### **Amendments to the Drawings**

### Remarks

FIG. 1A

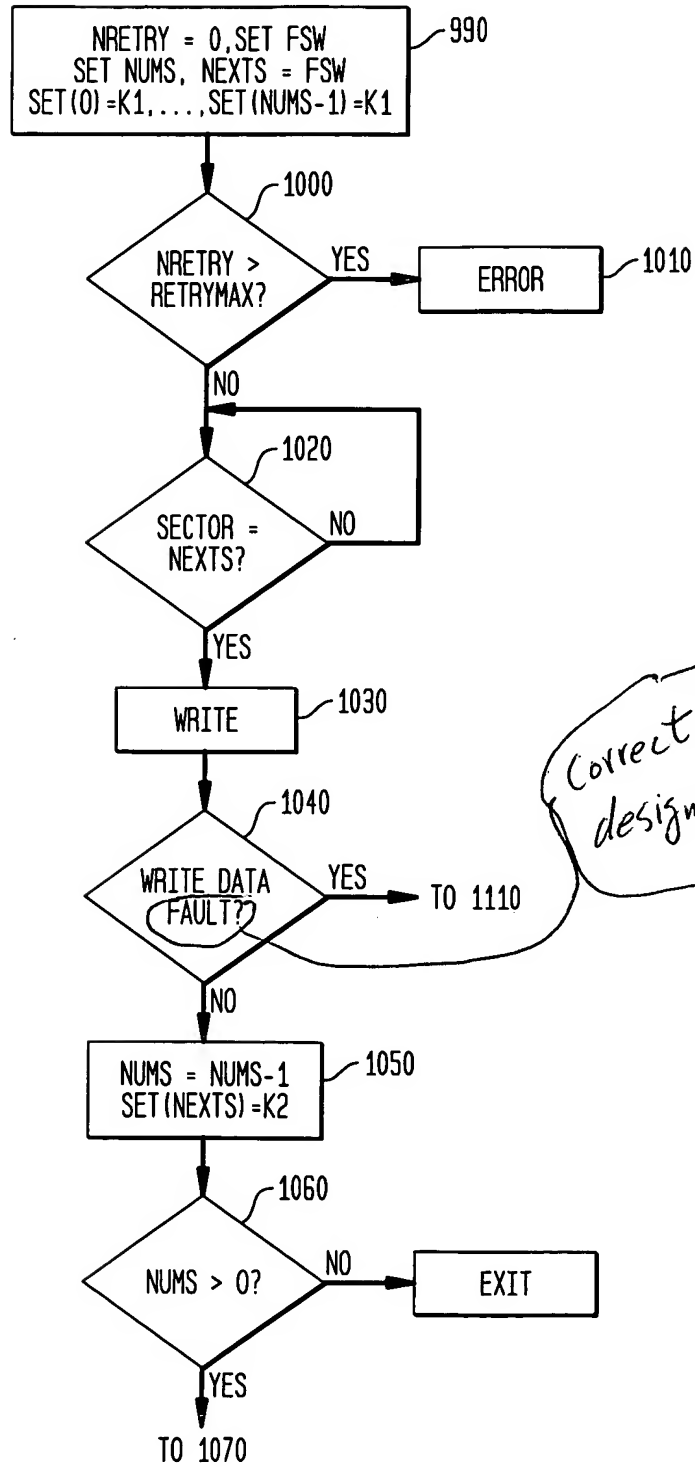
renumbered 1A

Correct previous designation default

FIG. 1B

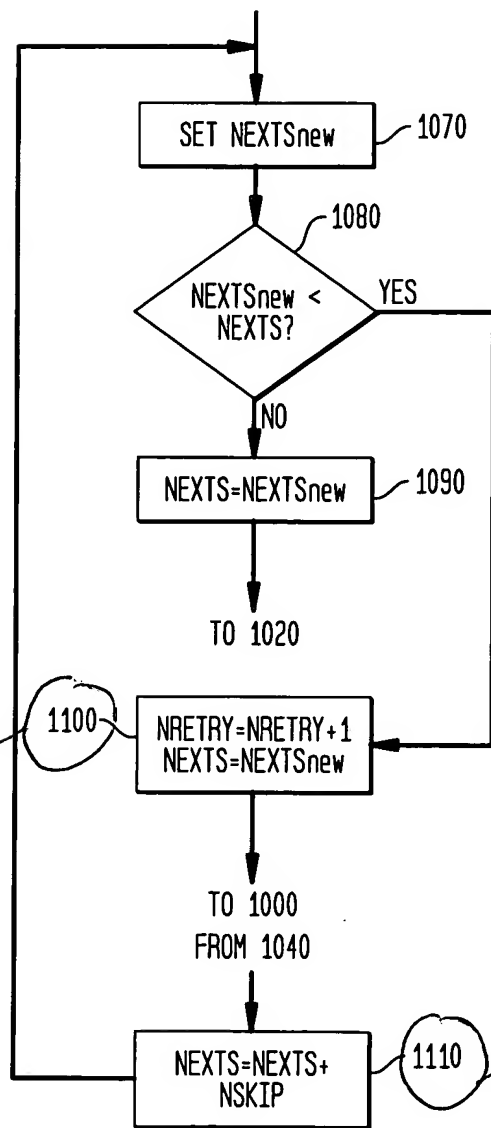
renumbered 1B

add missing  
number

add missing  
number

FIG. 2A

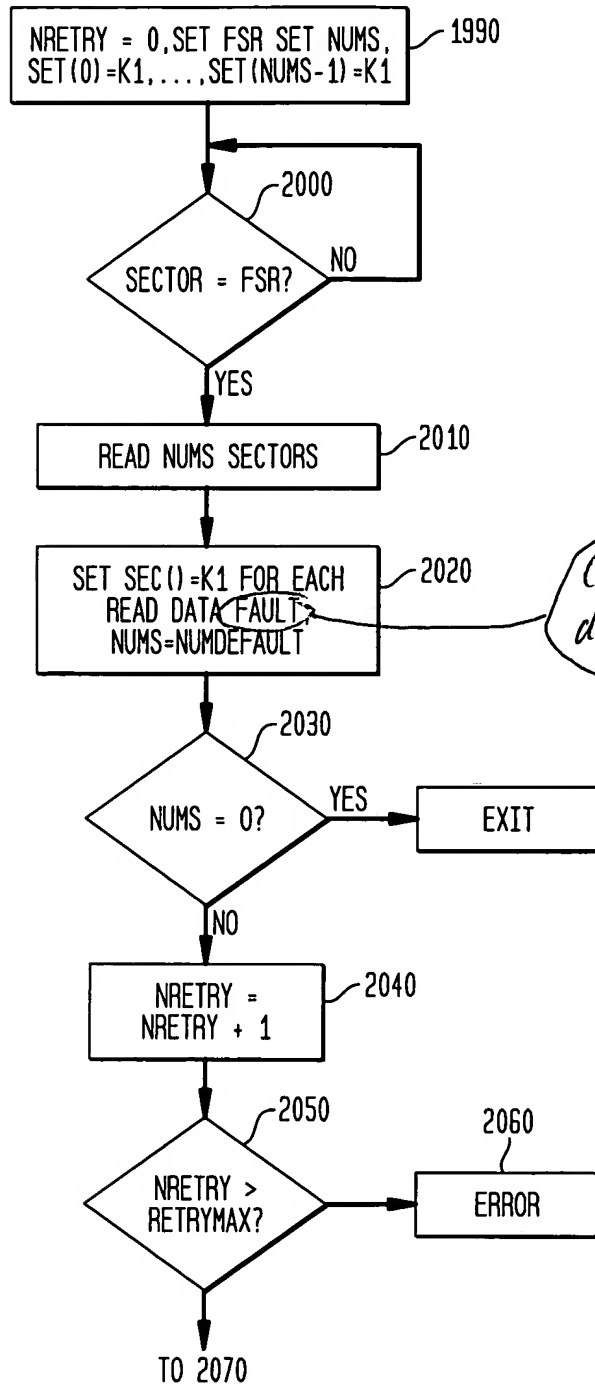
renumbered 2A

FIG. 2B

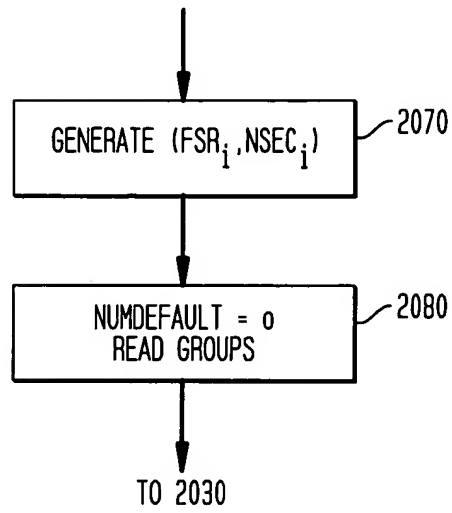
renumbered 2B

FIG. 3A  
(PRIOR ART)

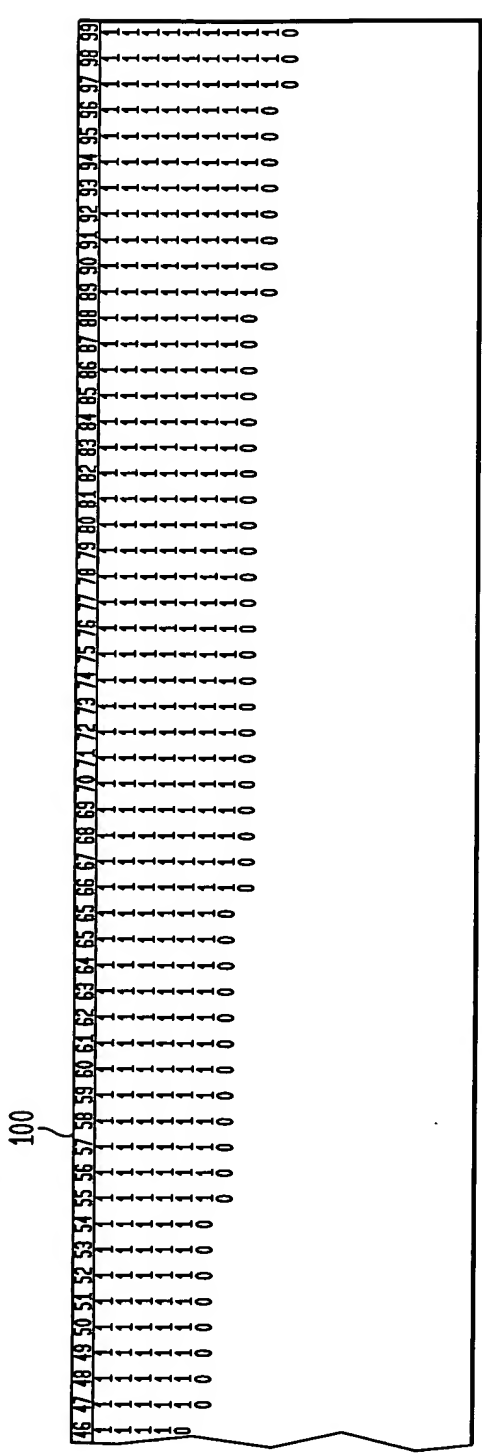
The drawings are objected to because they include sloppy lettering and lines and FIGs. 3 and 4 mix the “Prior ART” with applicant’s invention. It is suggested that the applicant present two separate figures for FIG. 3, as well for FIG. 4, one pertaining to the present invention and the other one labeled as “PRIOR ART”, i.e., FIGs. 3A and 4A “PRIOR ART”. It is also suggested that the applicant review all the submitted drawings for errors (i.e. page 4, paragraph 0016, line 6, “box 1110” of specification).

renumbered 3A

Added Label Prior Art

FIG. 4A  
(PRIOR ART)

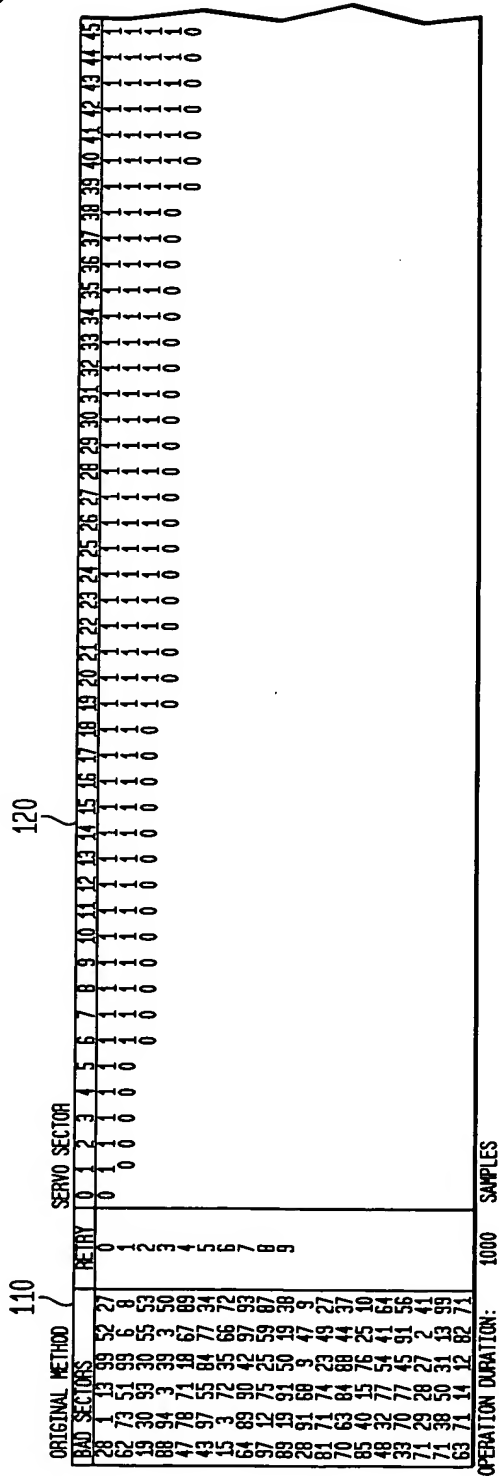
re numbered 4A

added label Prior Art

FIG. 4B

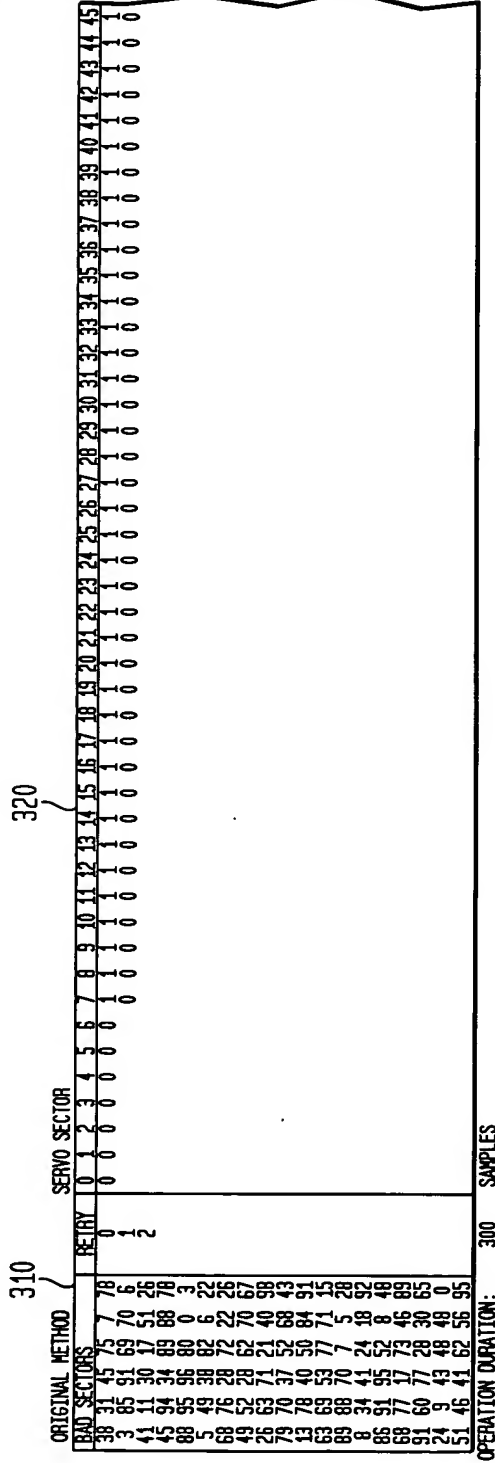
renumbered 4B
